TRUCK, CARGO, LIGHT, MC2, LAND ROVER 110 6X6 - ALL TYPES

REPLACEMENT OF THE LOWER THROTTLE LINKAGE LEVER

MODIFICATION INSTRUCTION

Figure 1 - Throttle Linkages

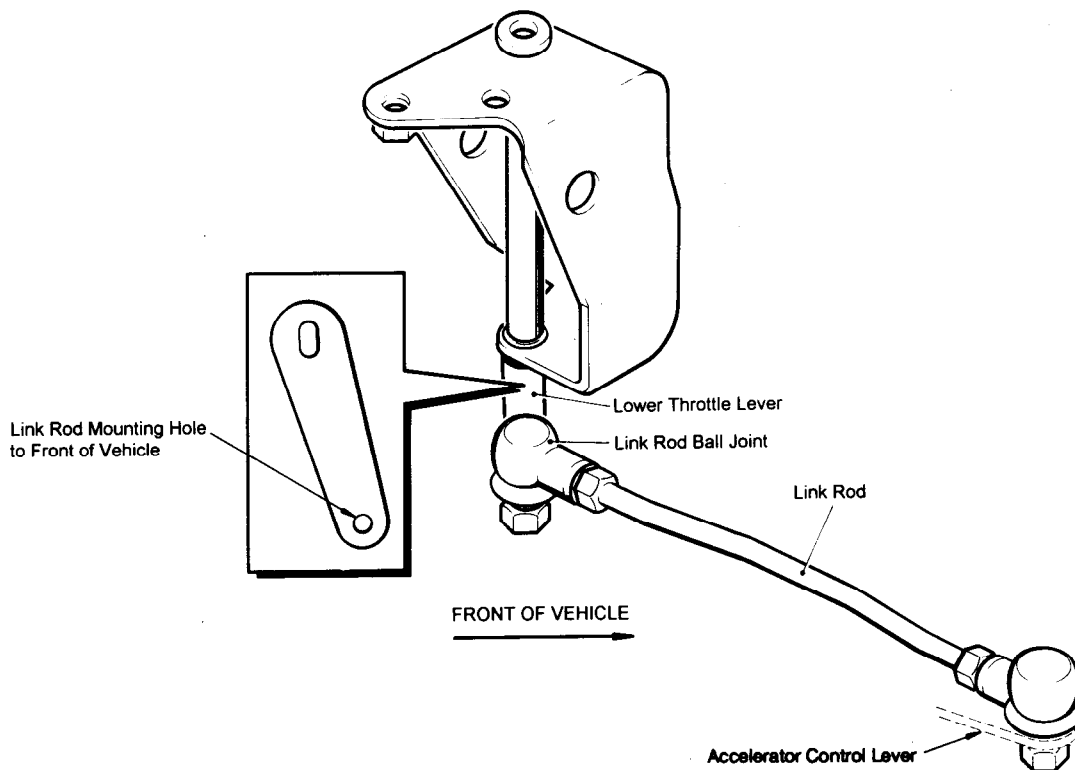
1. This instruction details the replacement of the existing lower throttle linkage lever with a modified lever and adjustments to the fuel injection pump, to allow full throttle travel. The replacement is due to an Engineering Change by Land Rover Australia and is necessary to ensure full power is obtained whilst driving.

- a. Ensure that the engine is at operating temperature.
- b. Replace the lower throttle lever, see Figure 1, with the new lever (item 1 from Table 2), ensuring that the link rod mounting hole is toward the front of the engine.
- c. Leave the link rod ball joint disconnected from the throttle lever and, if necessary,

It may be necessary on some vehicles to remove and trim the link rod (see Figure 1) by 5 mm to allow full adjustment of the linkages.

- d. Refit and adjust the link rod to achieve 3550 - 3650 rpm when the accelerator pedal is fully depressed.

Figure 2 - Idle and Maximum Speed Screws

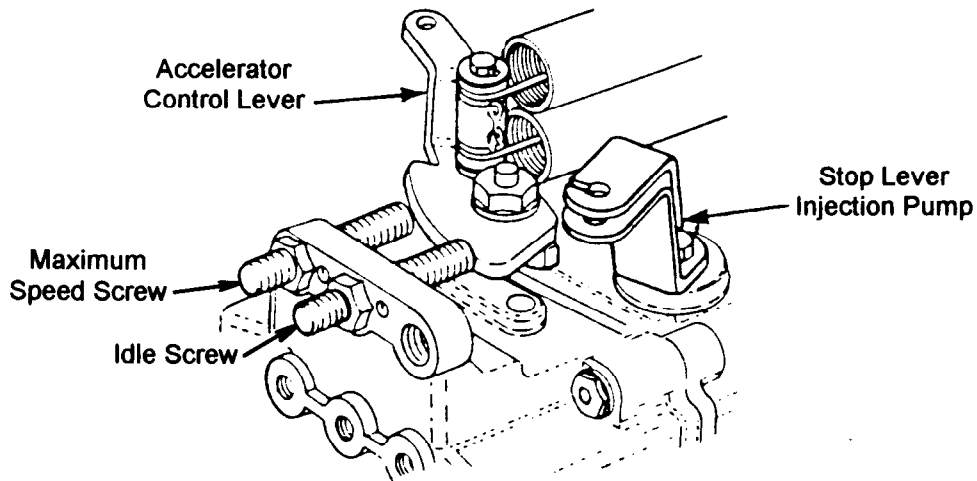
adjust the maximum speed bolt on the fuel injection pump governor to obtain 3550 - 3650 rpm and the idle set bolt to obtain 630 - 670 rpm (Figure 2 shows the relative screws).

Figure 3 - Accelerator Pedal Tang

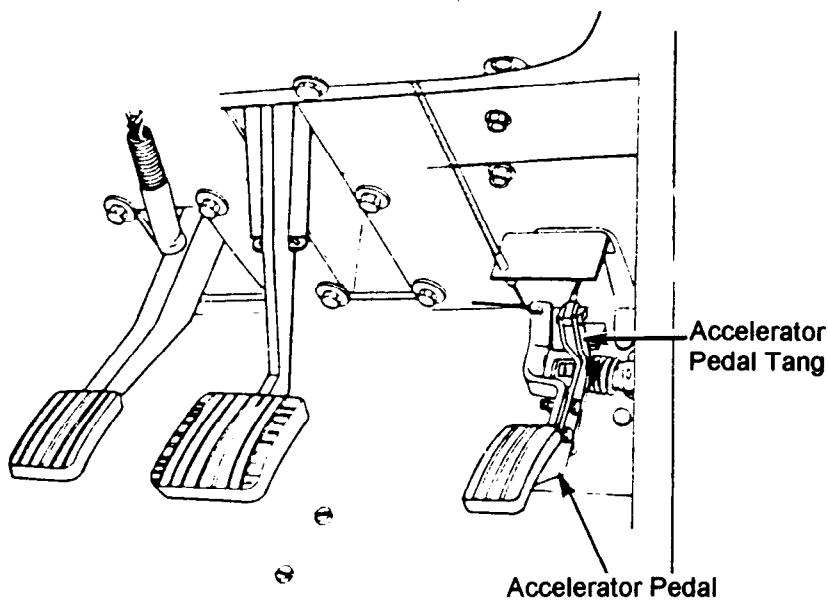
- e. If engine idle speed exceeds 630 - 670 rpm bend the tang at the top of the accelerator pedal, see Figure 3, to allow the pedal to fully return to the idle position.
